Notice of Modification

Section 75W of the *Environmental Planning and Assessment Act 1979*

The project approval (09_0080) for the Champions Quarry Project, granted by the Planning Assessment Commission as delegate of the Minister for Planning and Infrastructure on 30 August 2012.

Figure 3: Site Features and Neighbouring Receivers

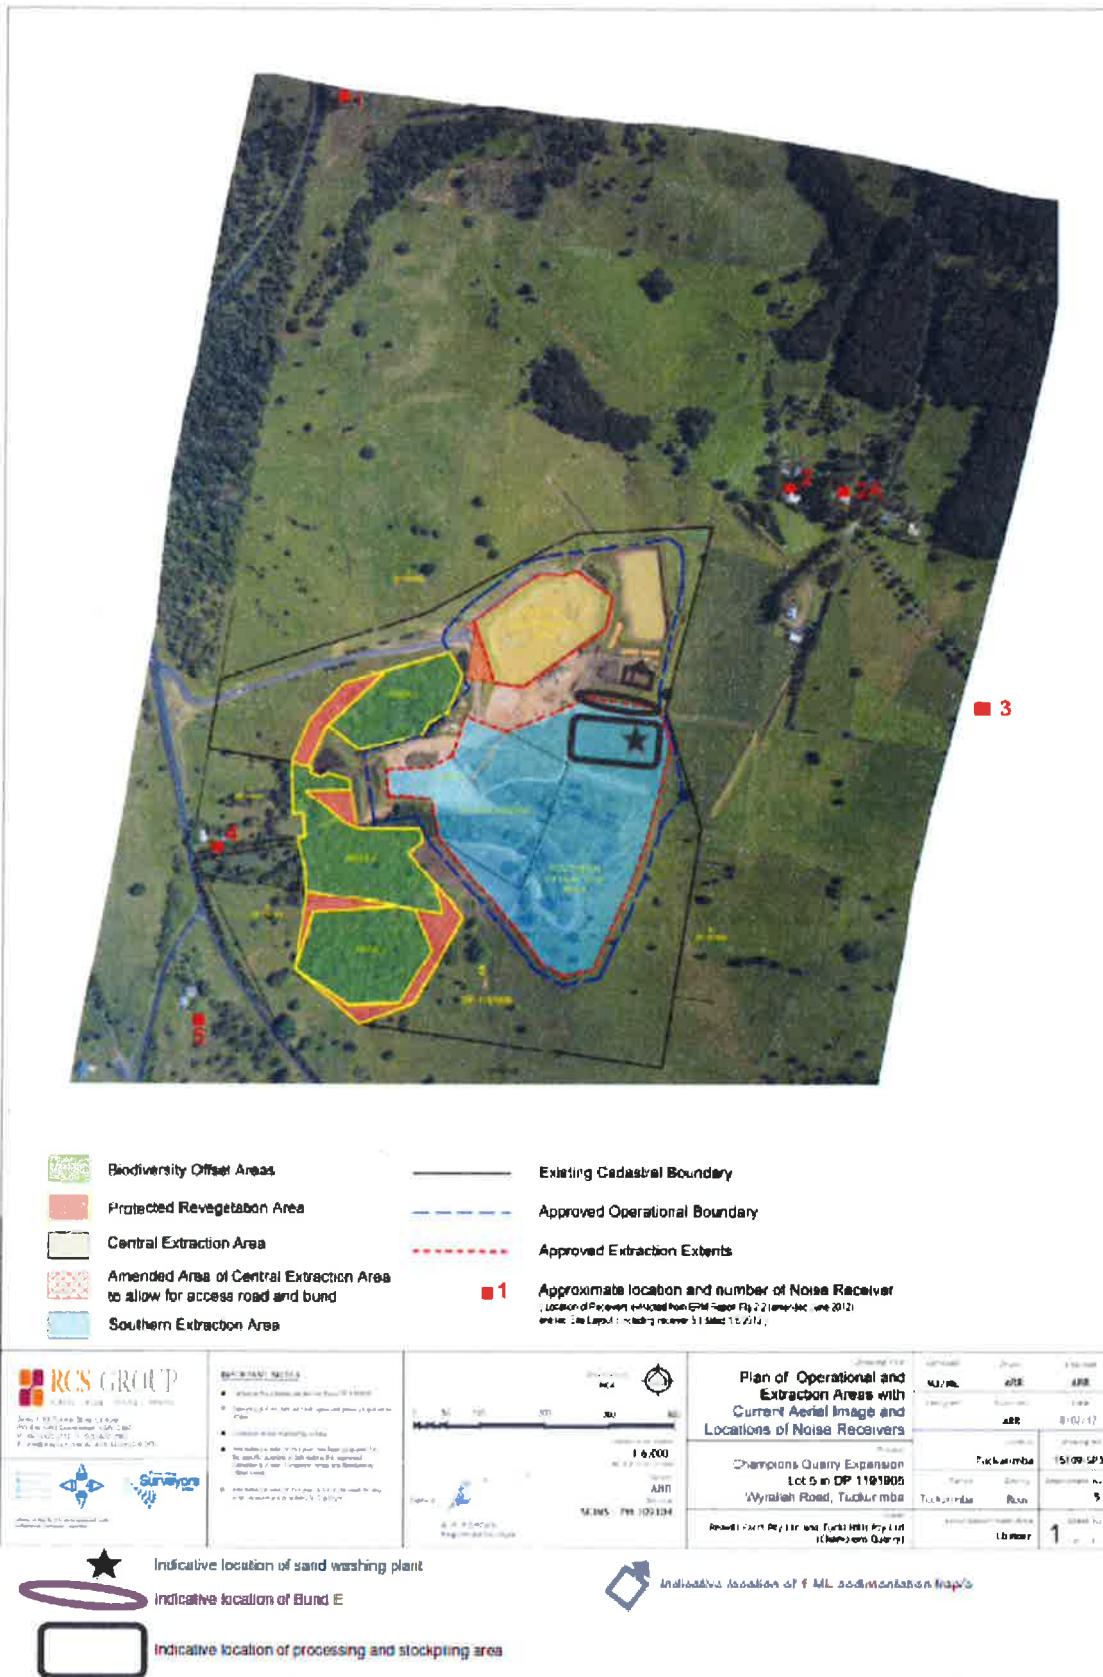
- (a) consult with the relevant public authority prior to submitting the required document to the Secretary for approval;
 - (b) submit evidence of this consultation as part of the relevant document;
 - (c) describe how matters raised by the authority have been addressed and any matters not resolved; and
 - (d) include details of any outstanding issues raised by the authority and an explanation of disagreement between any public authority and the Applicant.
11. In Appendix 2 – Project Layout Plans, delete Figure 3 and replace with the following:
